**PART 573 Defect and Noncompliance Report**

Generic name of the item: Passenger floorboard mount

Part Number: Kuryakyn Part No. 607005

**New mount design**

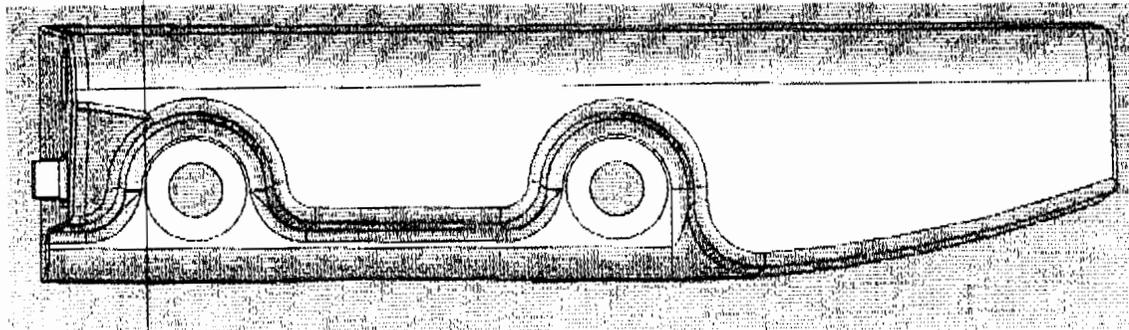
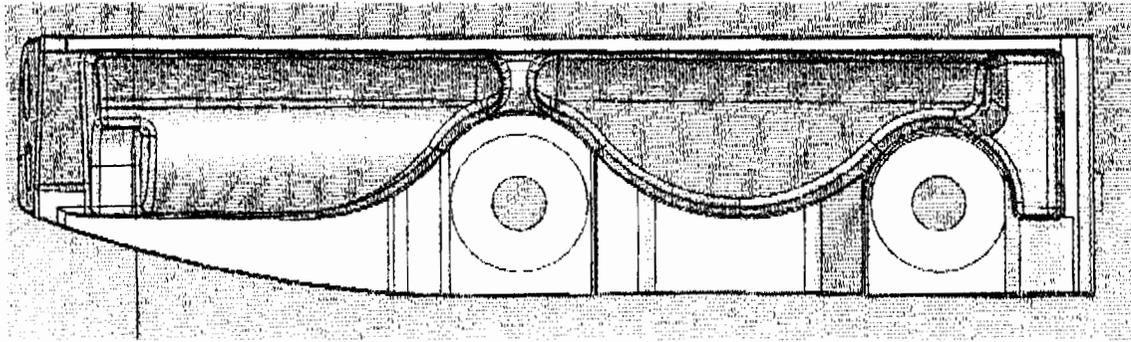
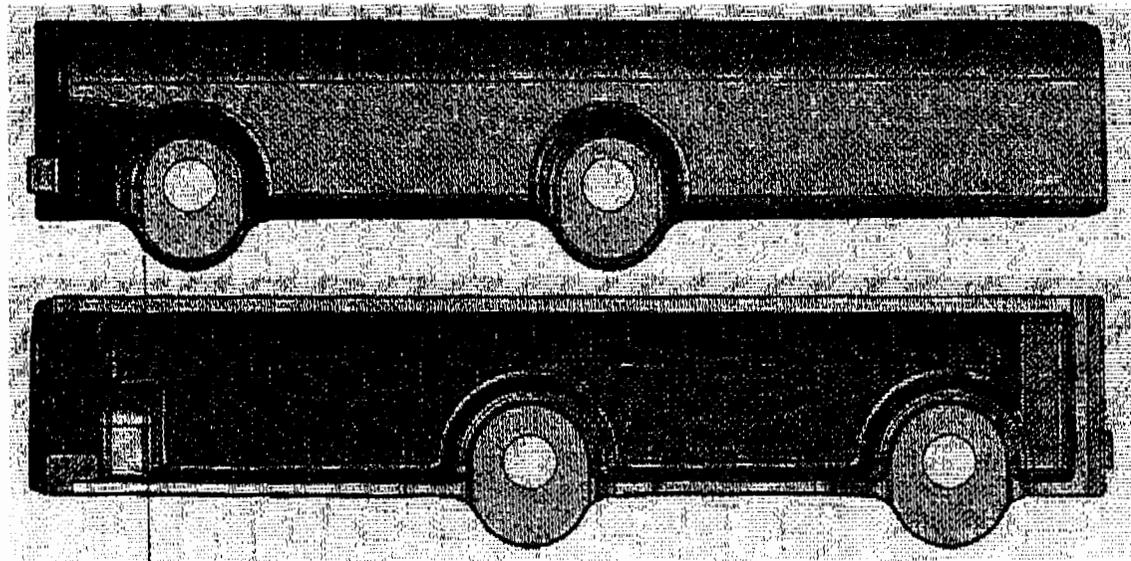
Kuryakyn has redesigned the mount in the following respects (see pictures below):

A. Thicker wall sections along the lower surfaces.

B. Add gusset rib along lower rear edge.

C. Add center gusset rib inside casting.

D. Material changed to a stronger material.
